# Error Generates When SSR is Moved into an Engine Brake Position 1, 2, 3

FIELD SOLUTION: TSB 26-058 FTL and 26-009 WST

PUBLISH DATE: 9/15/2025

## VISUALIZATION:

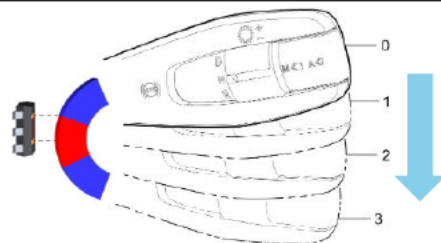
- A select range of right-hand stalk switches may have internal damage, causing a consistent fault where the engine brake fails to activate and a fault code is generated when the lever is moved to the engine brake positions, which becomes inactive when moved to the OFF position.

Engine Brake	Right Stalk Switch Position	Display Status
OFF	ON	Neutral
OFF	level 0	ON
OFF	ON	Neutral
OFF	error	ON
OFF	ON	Neutral
OFF	error	ON
OFF	ON	Neutral
OFF	error	ON

- January 27, 2025
- BCS (stalk switch supplier) uses a Hall effect sensor in place of a microswitch

- TSB 26-058 FTL and 26-009 WST published to aid the diagnosis of a failed microswitch to prevent diagnostics that could lead to replacing the CPC and other components.
- Current troubleshooting does not lead technicians to diagnosing the stalk switch for this symptom which can result in CPC replacement that will not correct the issue and substantially increase the cost of repair.
